HISTORIC AND DESIGN REVIEW COMMISSION

February 20, 2019

HDRC CASE NO: 2018-451
ADDRESS: 607 E LOCUST
LEGAL DESCRIPTION: NCB 1735 BLK 14 LOT 3
ZONING: MF-33, H
CITY COUNCIL DIST.: 1
DISTRICT: Tobin Hill Historic District
APPLICANT: Jose Calzada/Architectura SA
OWNER: Rafael Saavedra Sada/Aster Development LLC
TYPE OF WORK: Construction of a 3-story multifamily structure and 3-story accessory structure
APPLICATION RECEIVED: February 07, 2019
60-DAY REVIEW: April 06, 2019
REQUEST:

The applicant is requesting final approval to construct a 3-story multifamily structure and a 3-story rear accessory structure at 607 E Locust.

SURROUNDING BUILDING HEIGHTS

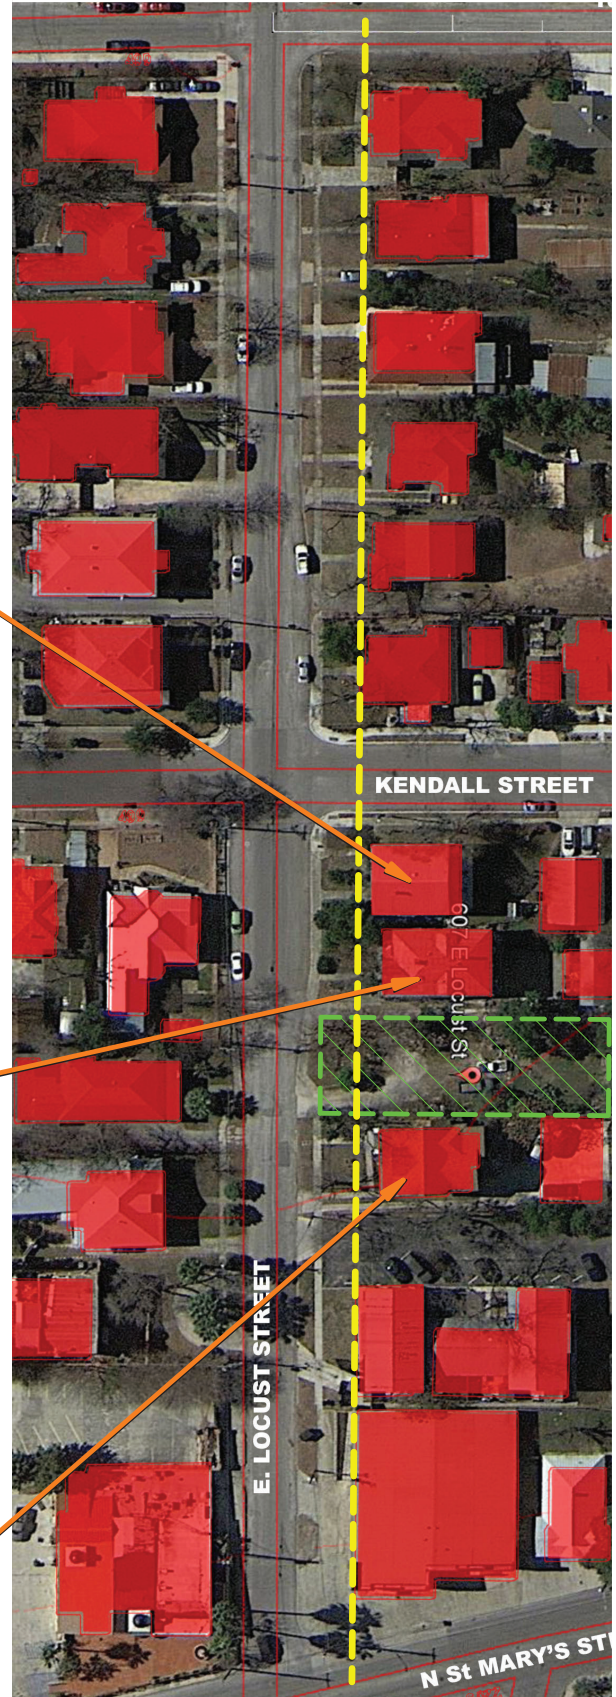
- g. **SCALE & MASS** – The applicant has proposed two 3-story units. One will be located along the street frontage of E Locust and one will be located in the rear of the property. Per the submitted elevations, the ridgeline of the units is approximately 32'. Guideline 2.A.i stipulates that the height and scale of new construction should be consistent with nearby historic buildings and should not exceed that of the majority of historic buildings by more than one-story. Per the submitted elevations, the applicant has indicated that the 2-story historic structures directly to the east and west are approximately 30-31 feet. Staff finds that the architectural detailing and materiality visually reduces the perceived height of the third floor. Staff finds the overall height to be generally acceptable given the specific context of this portion of the E Locust and the district.

1 THIRD LEVEL. FLOOR PLAN
1/4" = 1'-0"

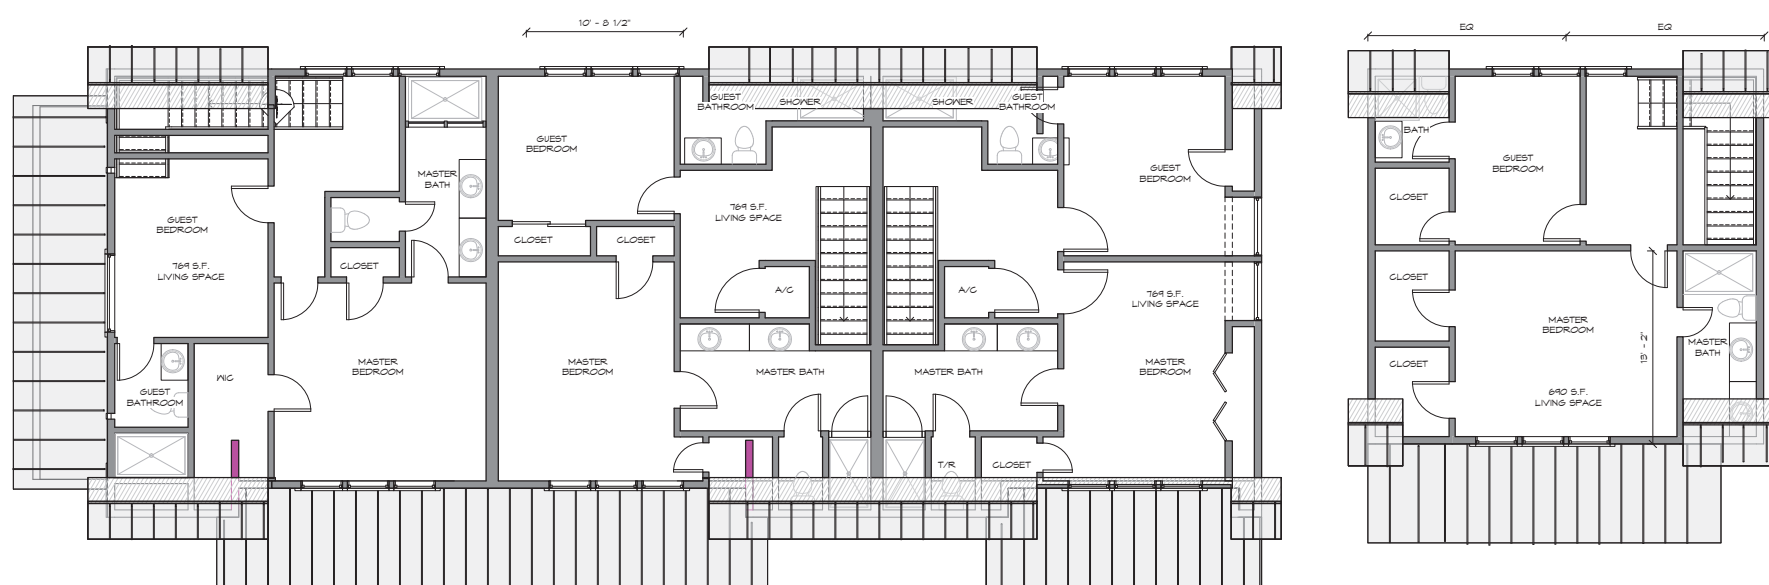
- k. **WINDOW & DOOR OPENINGS** – According to the Historic Design Guidelines for New Construction, window openings with a similar proportion of wall to window, as compared to nearby historic facades, should be incorporated. Similarity is defined by windows that are no larger than 25% in size and vary no more than 10% in height to width ratio from adjacent historic facades. The applicant has proposed several window and door openings that generally feature sizes that are found on historic structures. However, the front and rear elevation contain a window on the third story that deviates from traditional proportions and scales. Staff finds that this window should be modified to be more consistent with the proportions traditionally found on 2-1/2 story structures in the district.

- iii. That the applicant modifies the front window on the 3rd story to be more consistent with fenestration sizes and proportions in the district. A final drawing set is required for staff review and approval prior to the issuance of a Certificate of Appropriateness.
